CITY OF DELAND
REGULAR MEETING OF THE TECHNICAL REVIEW COMMITTEE
MAY 21, 2026 AT 1:30 PM
CITY OF DELAND TRC MEETING ROOM
DELAND, FLORIDA

CITY OF DELAND
TECHNICAL REVIEW COMMITTEE MEETING
MEETING MINUTES
THURSDAY, APRIL 16, 2026 -1:30 P.M.
CITY HALL

Issues for record SP24-068

Issues for record PSB25-015

Issues for record MS26-090
Job Address: 536 W ARMSTRONG AV, DELAND FL 32720
Job Description: subdivide into two lots

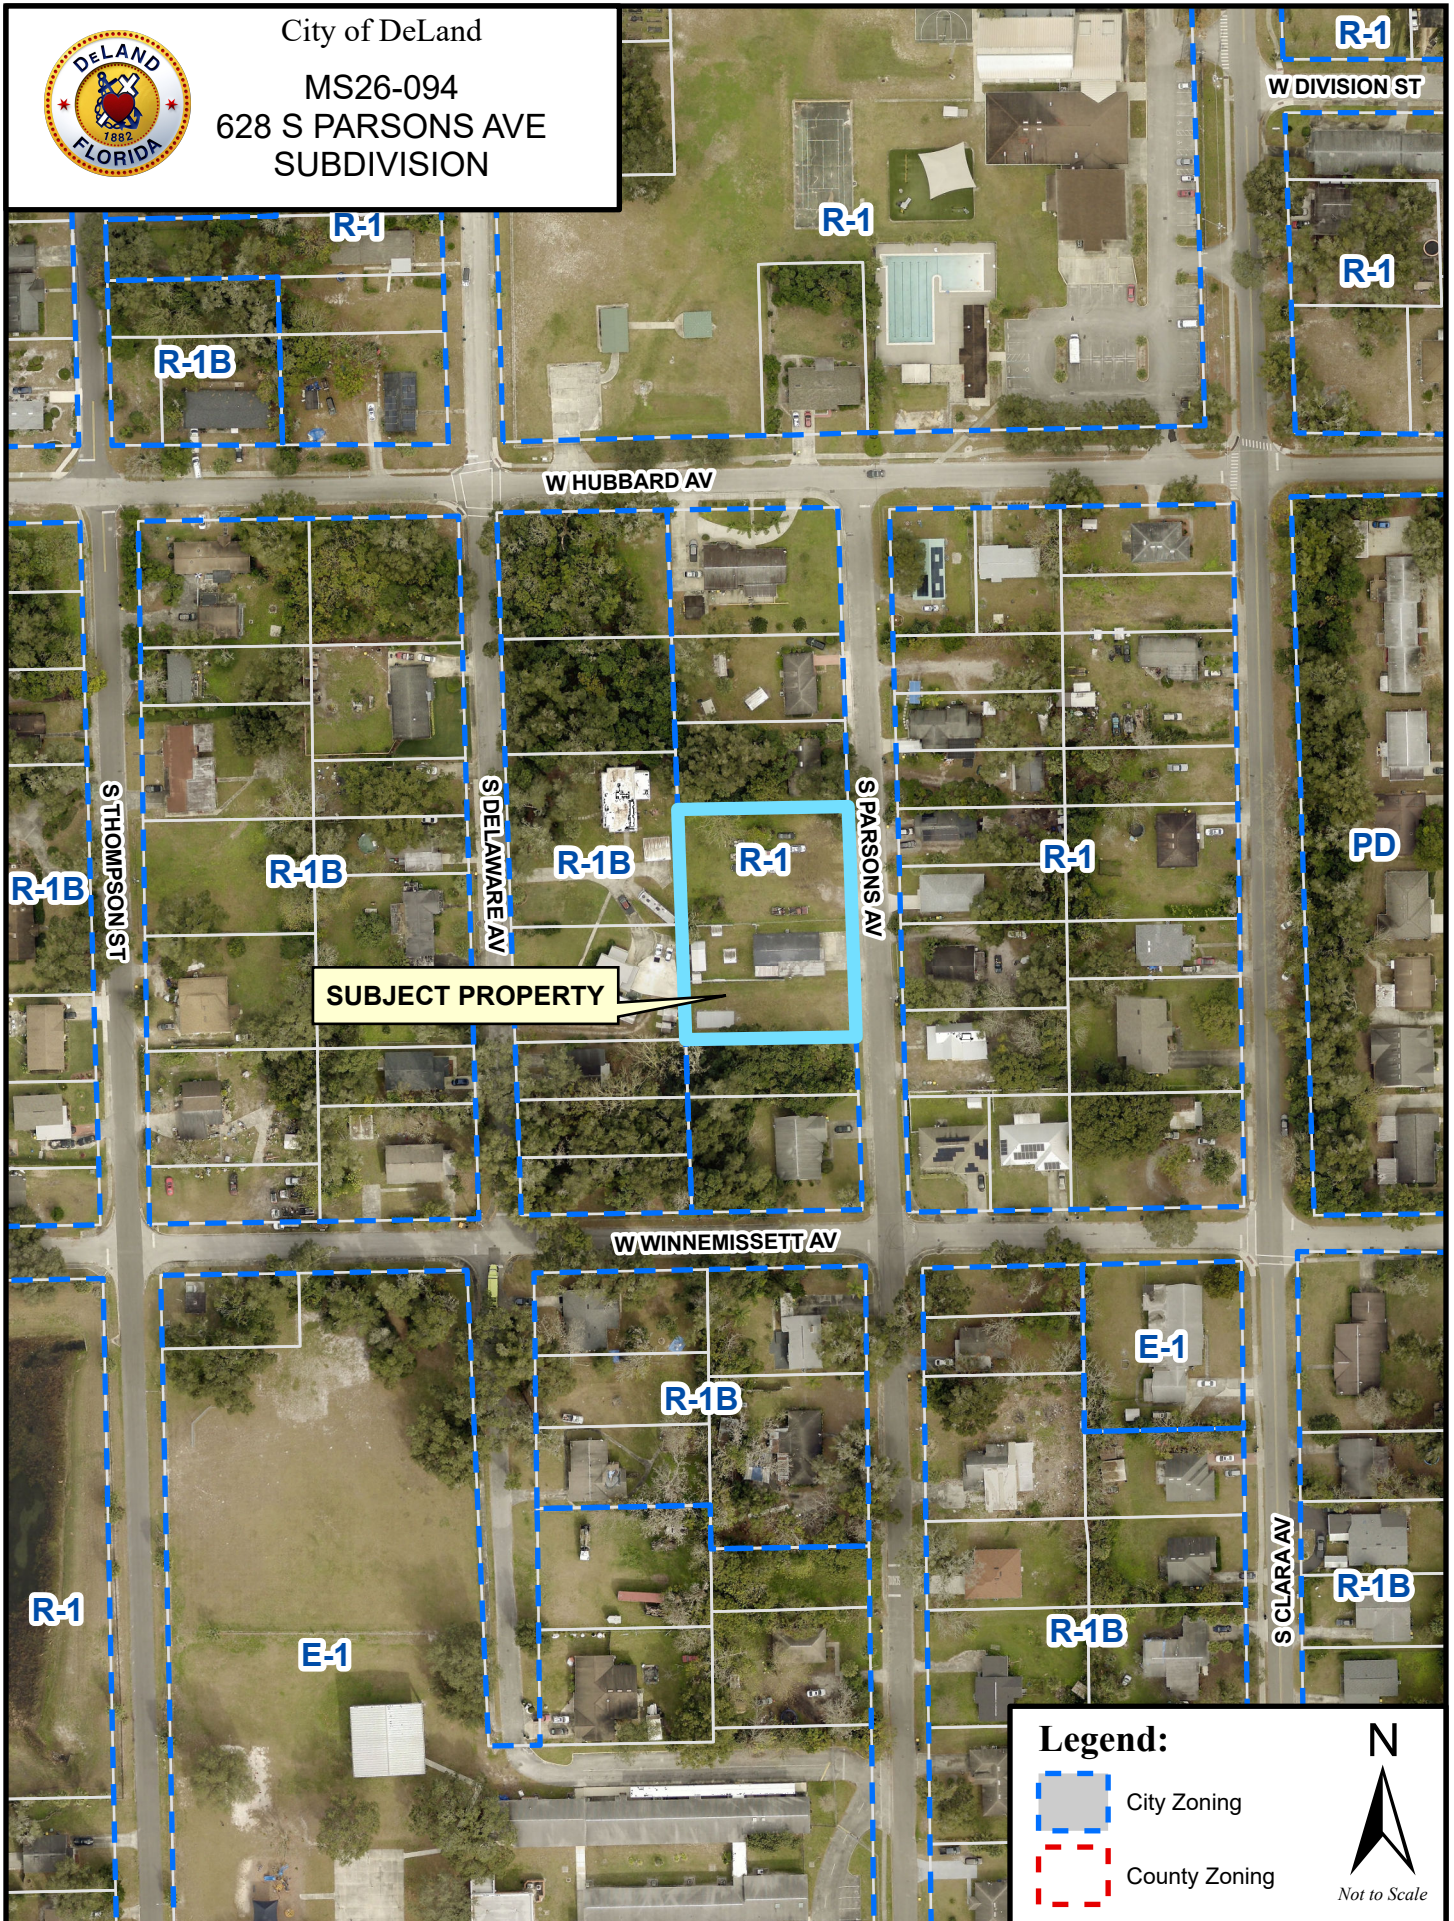
No	Discipline	Status	Details	Attached To	Created By	Last Updated By	Modifications Required
1	Forestry	Open	Tree Survey Please provide an historic tree survey or provide a note on the plan that there are no historic trees.	1	Laureen Korneel	Samuel Nelson	Yes
4	Planning	Open	Vehicle Use Area - Surface Material The Land Development Regulations currently require all vehicle use area to be paved with concrete, asphalt concrete, or an industry recognized porous paving system. This will be required when development occurs on proposed Parcel A. Parking meeting the current code standard may be required for the existing residence on proposed Parcel B whenever significant renovation or addition occurs.	2-51-26 Proposed Lot split.pdf	Samuel Nelson	Samuel Nelson	Yes
3	Planning	Open	Lot Size When measuring the parcels, I did not obtain the shown areas. Please confirm that proposed parcel areas are correct.	2-51-26 Proposed Lot split.pdf	Samuel Nelson	Samuel Nelson	Yes

2	Planning	Open	Structures on Vacant Lot Accessory structures (Fences, pavement) are not allowed without permitted principal development (House). The highlighted structures must be removed prior to the final subdivision.	2-51-26 Proposed Lot split.pdf	Samuel Nelson	Samuel Nelson	Yes
5	Utilities	Open	Services The current house on 536 is hooked up to both water and sewer. Only a 3/4" water line is available on Armstrong at this time to serve the proposed lot. The gravity sewer line stops at the driveway for the current address. It is shallow and may not be able to gravity flow, but could connect with a pump station.	1	Jim Alles	Samuel Nelson	Yes

Issues for record MS26-094
Job Address: 628 S PARSONS AV, DELAND FL 32720
Job Description: Minor subdivision into 2 lots

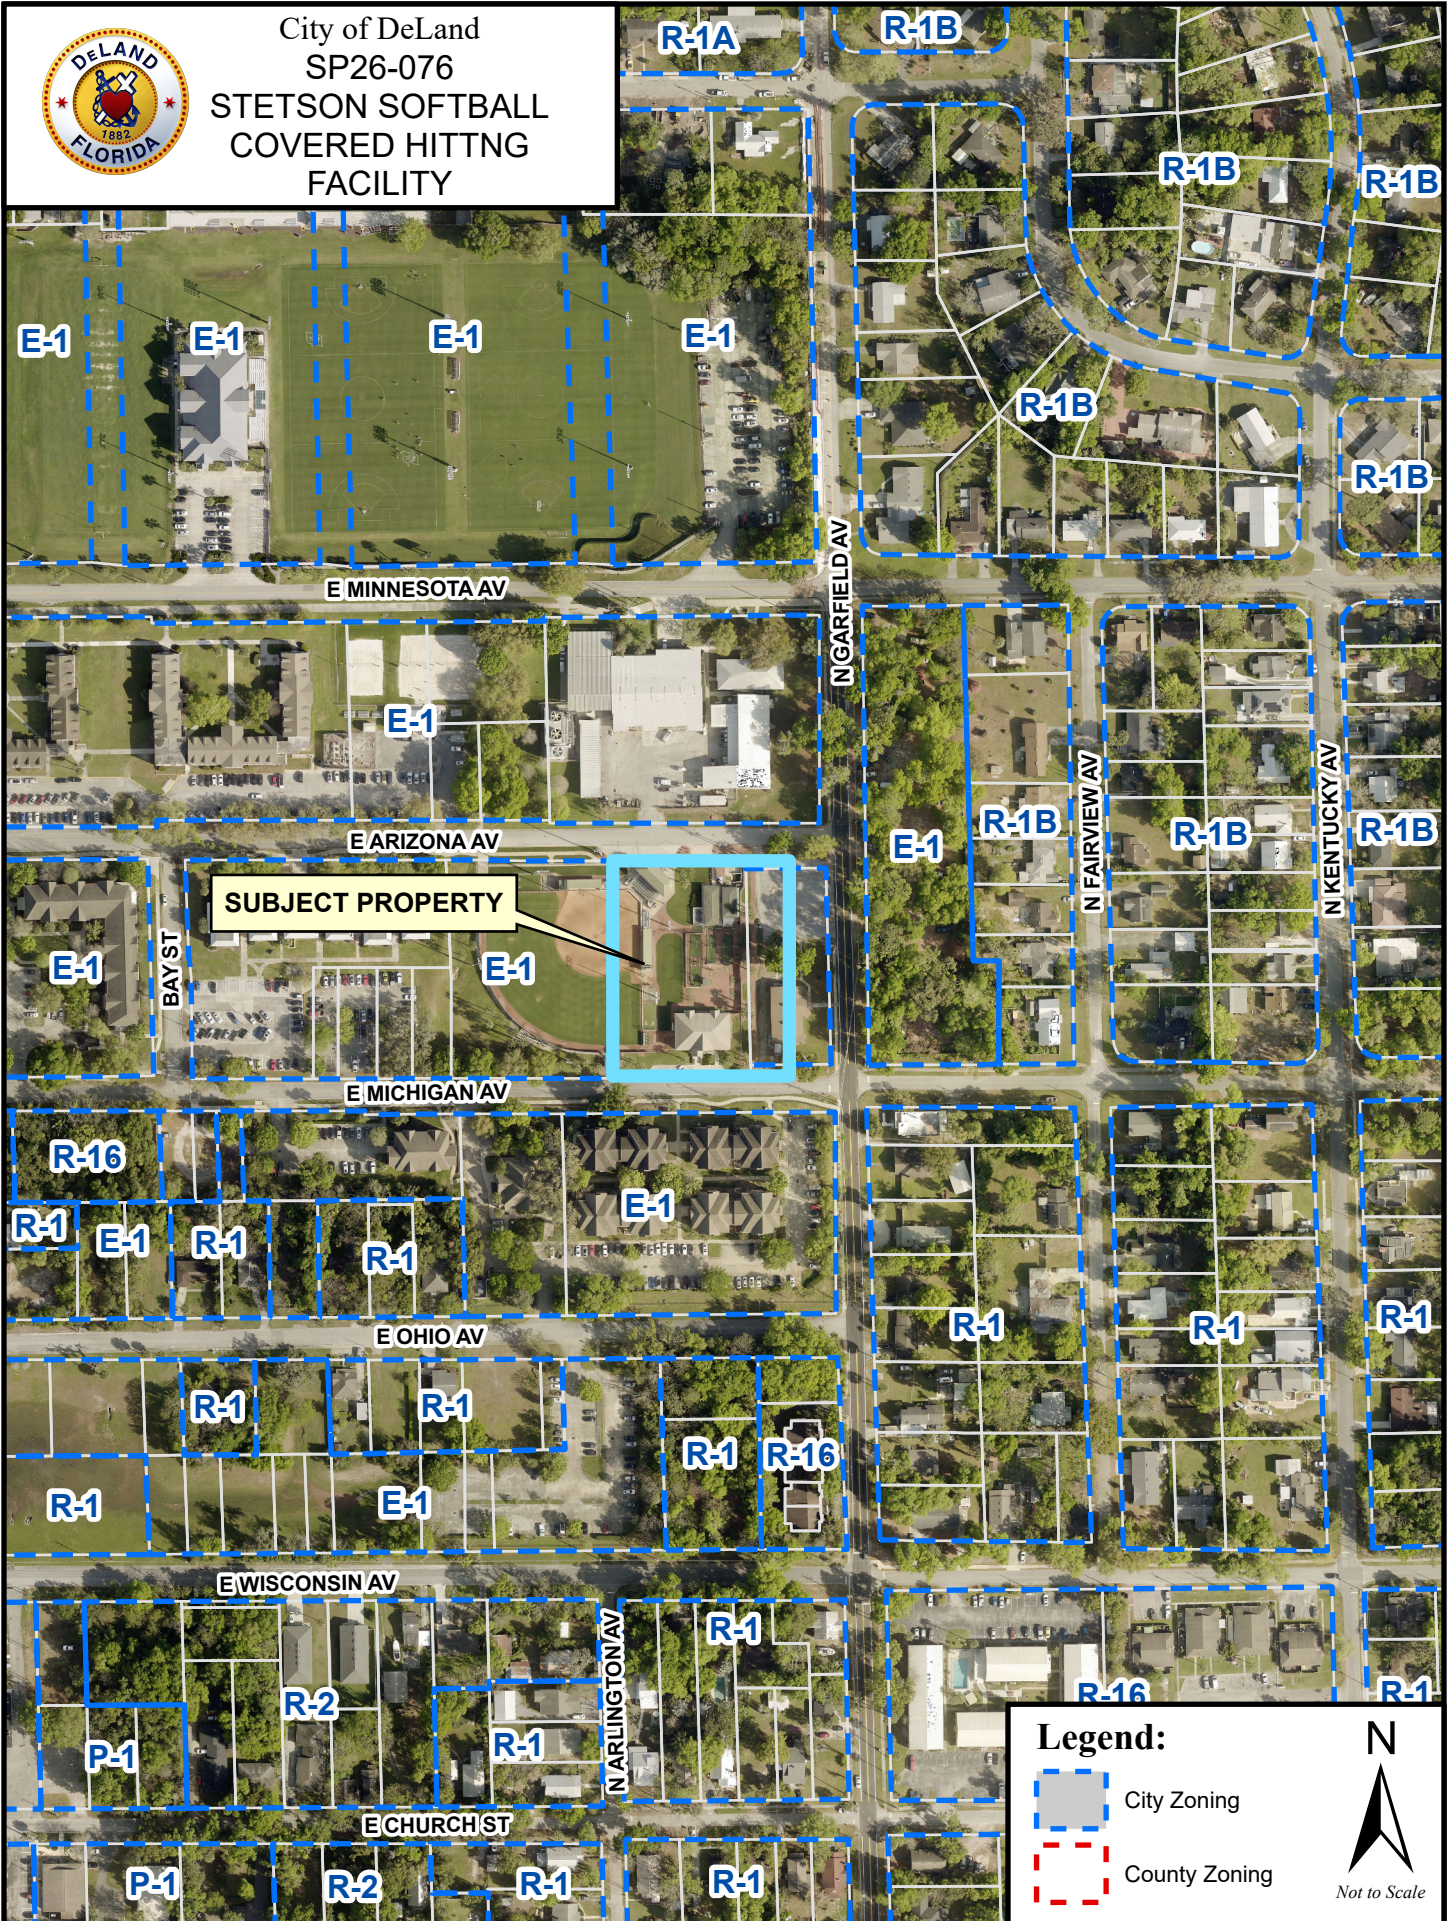
No	Discipline	Status	Details	Attached To	Created By	Last Updated By	Modifications Required
4	Utilities	Draft	<p>Services A 2" water line is available for connection for the new parcel and it also shows it has a sewer lateral.</p>		Jim Ailes	Jim Ailes	Yes
3	Planning	Draft	<p>Title Please revise proposed lot split to proposed minor subdivision.</p>	SKM_808260 43016510.pdf	Christopher Carson	Christopher Carson	Yes
2	Engineering	Draft	<p>Drainage Easement There is an existing east-west 24" storm drain located near the southern lot line of Proposed Parcel 1. Provide a 10' wide Drainage Easement centered over the existing storm pipe.</p>	SKM_808260 43016510.pdf	Steven Danskine	Steven Danskine	Yes
1	Forestry	Draft	<p>Tree Survey Please provide an historic tree survey or provide a note on the plan that there are no historic trees.</p>	SKM_808260 43016510.pdf	Laureen Kornel	Laureen Kornel	Yes
